Town of Hilton Head Island Regular Design Review Board Meeting

August 23, 2016

PROJECT NAME: Heritage Plaza Redevelopment Building D -
NEW DEVELOPMENT CONCEPTUAL

DRB#: DRB-001485-2016

PRELIMINARY SITE PLAN

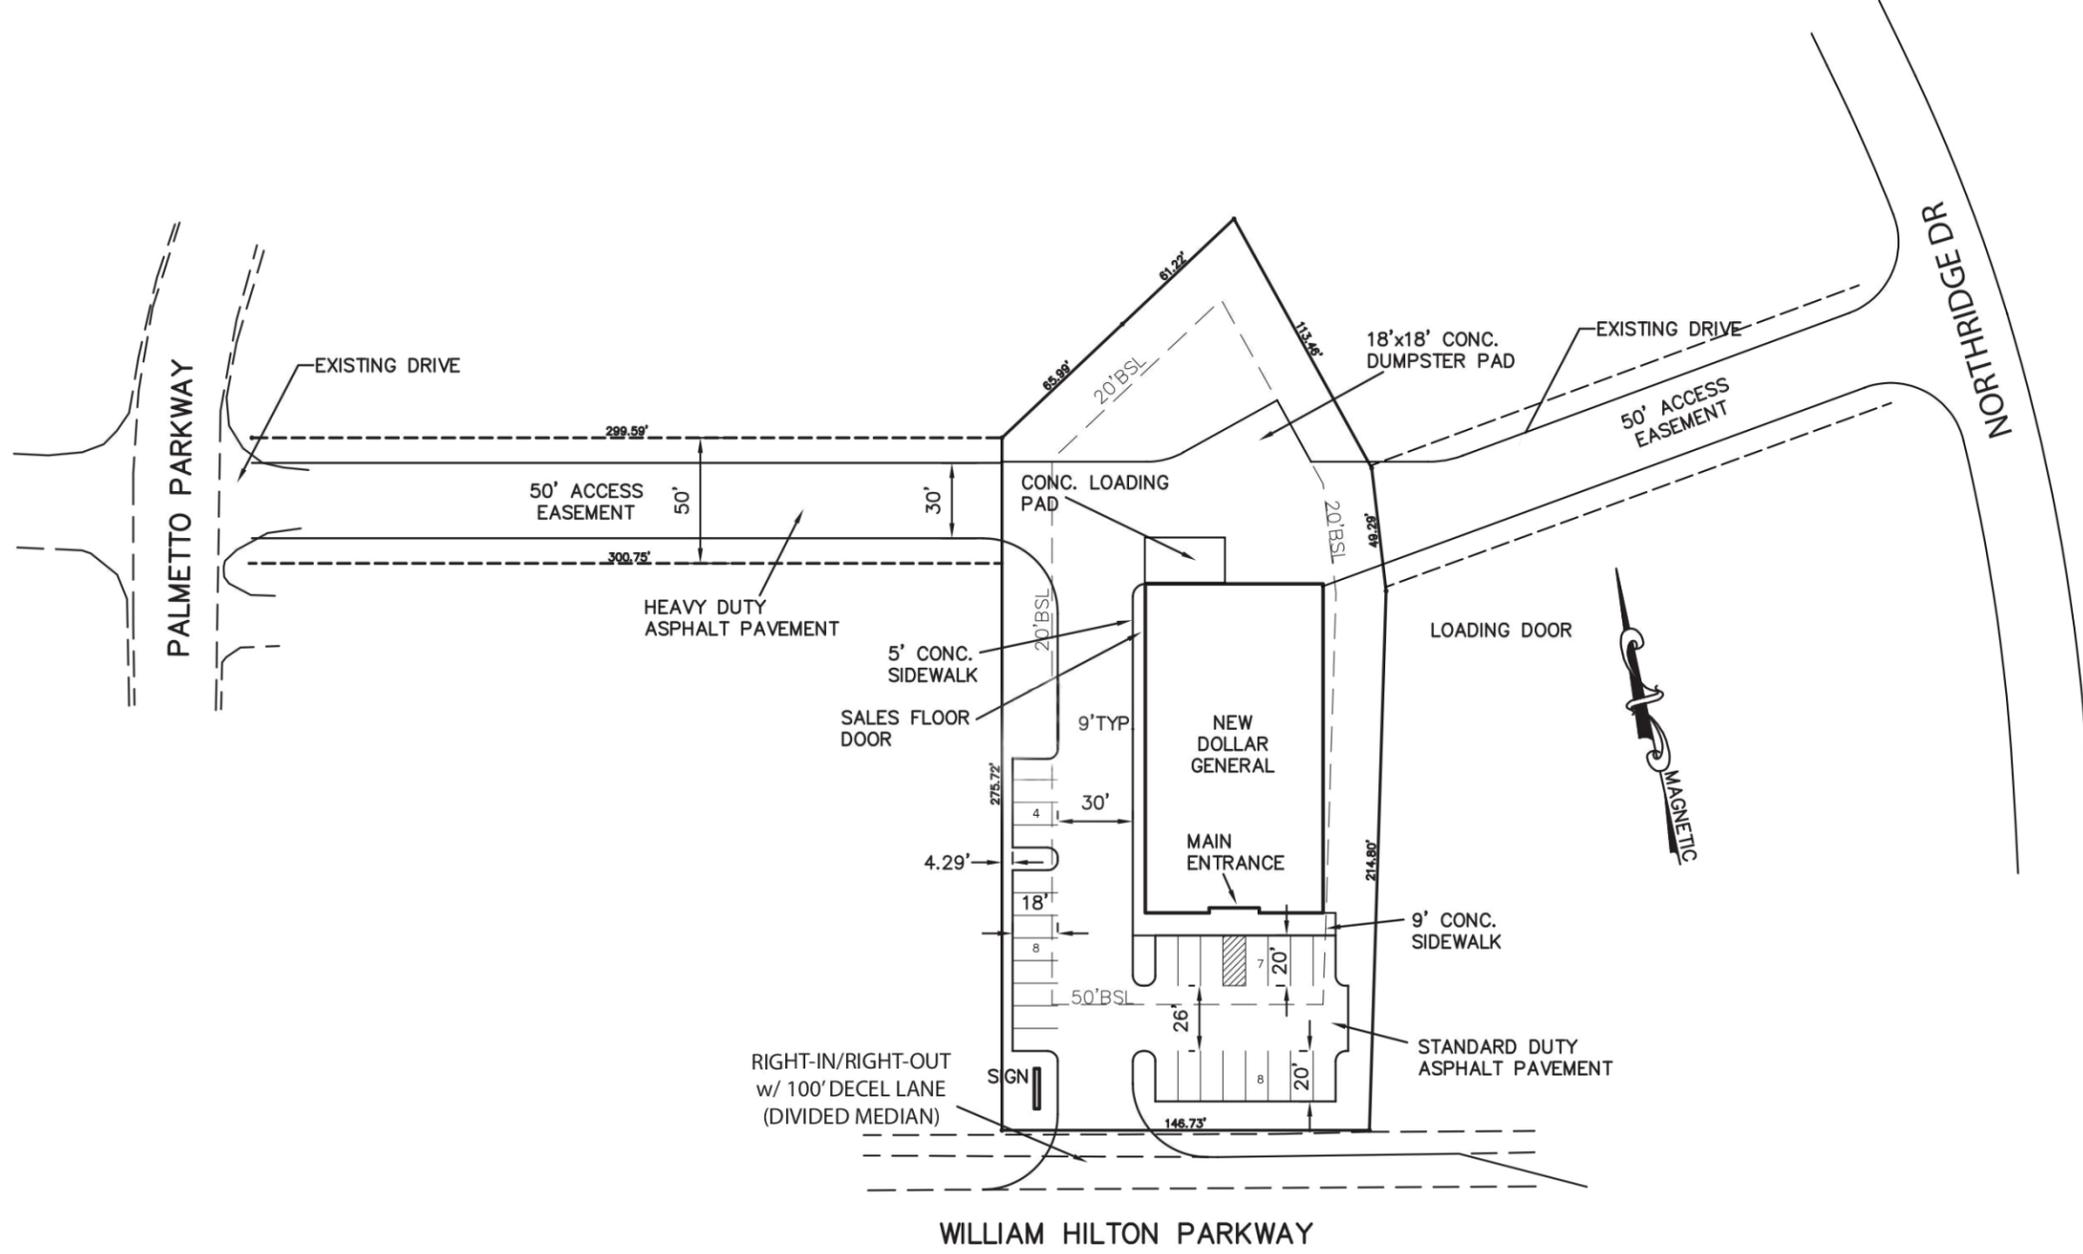
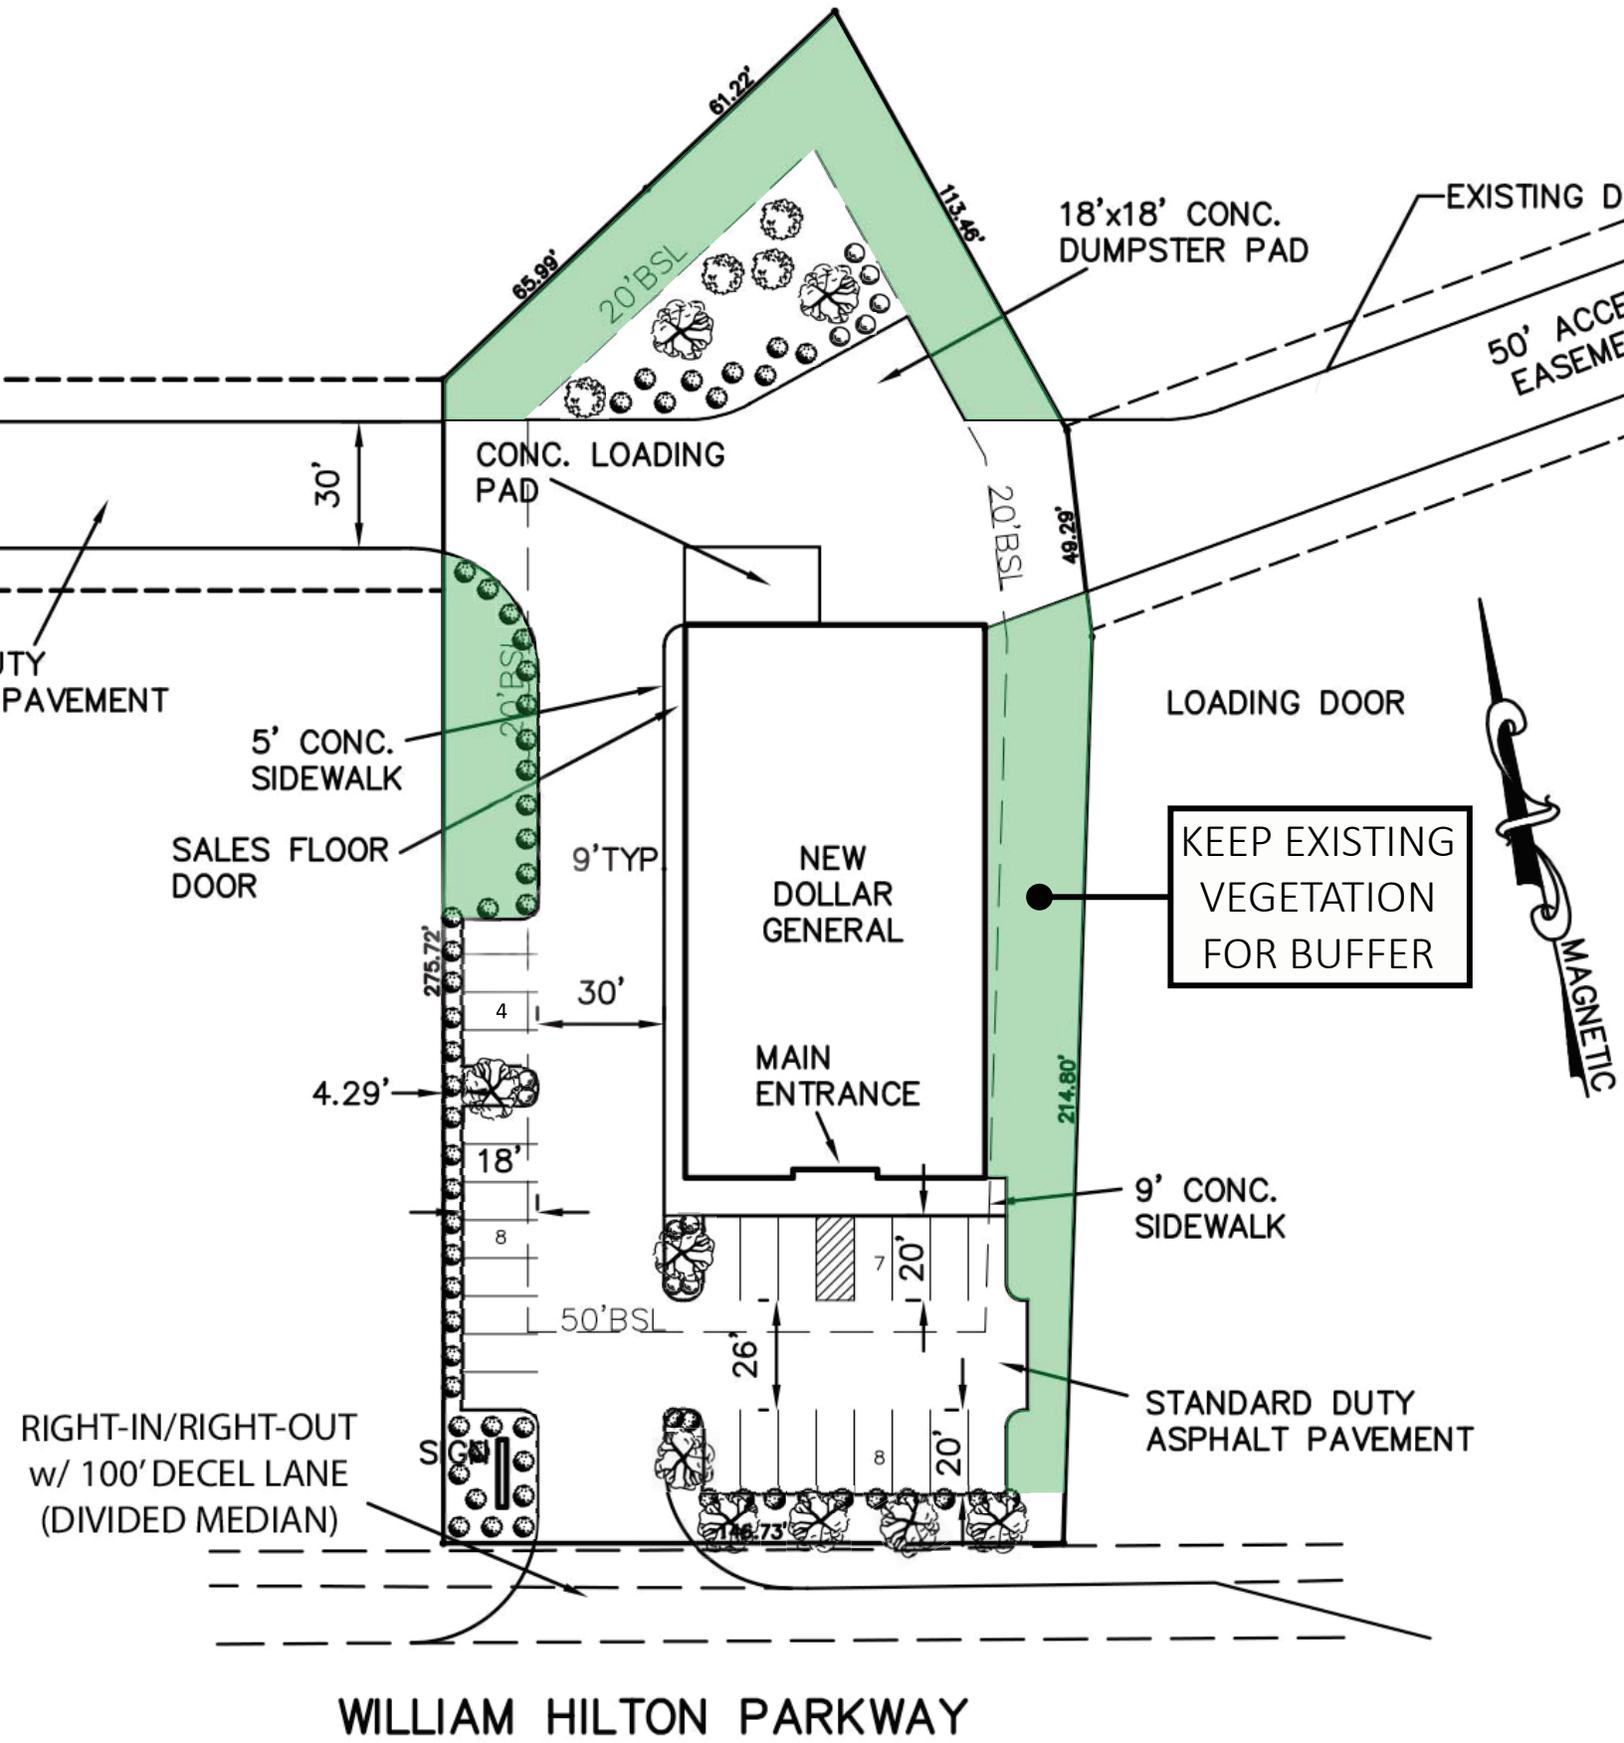
DESIGN GUIDE/LMO CRITERIA	Complies Yes	No	Not Applicable	Comments or Conditions
Treats the Landscape as a major element of the project	<input type="checkbox"/>	<input checked="" type="checkbox"/>	<input type="checkbox"/>	
Provides Landscaping of a scope and size that is in proportion to the scale of the development	<input type="checkbox"/>	<input checked="" type="checkbox"/>	<input type="checkbox"/>	Provide landscaping between building and parking.
Landscape is designed so that it may be maintained in its natural shape and size	<input checked="" type="checkbox"/>	<input type="checkbox"/>	<input type="checkbox"/>	
Preserves a variety of existing native trees and shrubs	<input checked="" type="checkbox"/>	<input type="checkbox"/>	<input type="checkbox"/>	
Provides for a harmonious setting for the site's structures, parking areas or other construction	<input type="checkbox"/>	<input checked="" type="checkbox"/>	<input type="checkbox"/>

Location of existing trees and new trees provides street buffers, mitigation for parking lots, and an architectural complement that visually mitigates between parking lots and building(s)	<input checked="" type="checkbox"/>	<input type="checkbox"/>	<input type="checkbox"/>	
Shrubs are selected to complement the natural setting, provide visual interest and screen less desirable elements of the project	<input type="checkbox"/>	<input type="checkbox"/>	<input checked="" type="checkbox"/>	
A variety of species is selected for texture and color	<input type="checkbox"/>	<input type="checkbox"/>	<input checked="" type="checkbox"/>	
Provides overall order and continuity of the Landscape plan	<input checked="" type="checkbox"/>	<input type="checkbox"/>	<input type="checkbox"/>

Front Elevation
1/16" = 1'-0"

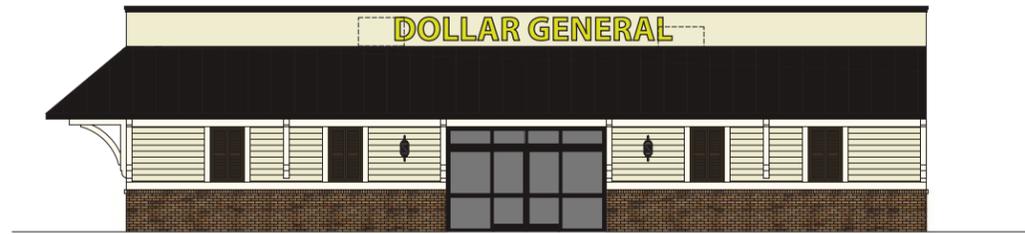
All facades are have equal design characteristics	<input checked="" type="checkbox"/>	<input type="checkbox"/>	<input type="checkbox"/>	No windows on right elevation but trim is used to break up non-pedestrian façade.
Avoids monotonous planes or unrelieved repetition	<input type="checkbox"/>	<input checked="" type="checkbox"/>	<input type="checkbox"/>	
Has a strong roof form with enough variety to provide visual interest	<input type="checkbox"/>	<input type="checkbox"/>	<input type="checkbox"/>	Attempts to solve issue of “hiding” equipment while providing pitched roof sections. Sea Pines reference includes smaller “parapet” section with standing seam and reads more as roof versus clipped on porch.

Minimum roof pitch of 6/12	<input type="checkbox"/>	<input checked="" type="checkbox"/>	<input type="checkbox"/>	Flat roof with pitched "porch".
Overhangs are sufficient for the façade height.	<input checked="" type="checkbox"/>	<input type="checkbox"/>	<input type="checkbox"/>	Overhang needs to wrap around right elevation to provide visual balance on front elevation.
Forms and details are sufficient to reduce the mass of the structure	<input checked="" type="checkbox"/>	<input type="checkbox"/>	<input type="checkbox"/>	
Human scale is achieved by the use of proper proportions and architectural elements	<input checked="" type="checkbox"/>	<input type="checkbox"/>	<input type="checkbox"/>	
Utilizes a variety of materials, textures and colors	<input checked="" type="checkbox"/>	<input type="checkbox"/>	<input type="checkbox"/>	Brick, siding, metal, wood
Incorporates wood or wood simulating materials	<input checked="" type="checkbox"/>	<input type="checkbox"/>	<input type="checkbox"/>

Windows are in proportion to the facade	<input type="checkbox"/>	<input type="checkbox"/>	<input type="checkbox"/>	Appear small/not enough on left elevation
Details are clean, simple and appropriate while avoiding excessive ornamentation	<input checked="" type="checkbox"/>	<input type="checkbox"/>	<input type="checkbox"/>	
Utilities and equipment are concealed from view	<input type="checkbox"/>	<input type="checkbox"/>	<input checked="" type="checkbox"/>	Provide screen (landscape and structural) for dumpster area and loading area.
Decorative lighting is limited and low wattage and adds to the visual character	<input type="checkbox"/>	<input type="checkbox"/>	<input checked="" type="checkbox"/>	
Accessory elements are design to coordinate with the primary structure	<input type="checkbox"/>	<input type="checkbox"/>	<input checked="" type="checkbox"/>

Per LMO Section 16-5-114.I.19, Prohibited Signs, signs where the sign or any portion of the sign is located on or extends above the roof of the building where the sign is located are prohibited. The proposed Dollar General sign in the front elevation show the sign on the parapet above the roof, which would be a violation of this section. Suggest instead installing a facade sign centered between the bottom of the roof and the top of the brick skirt. See LMO Section 16-5-114 for further sign standards. Contact Anne Cyran, Senior Planner, at 843-341-4697 to discuss sign design standards and permitting.

1. Provide additional landscaping in required buffers/setbacks as well as around service areas and pedestrian areas.
2. Consider modifications to roof as move to final submittal to eliminate appearance of flat roof beyond.
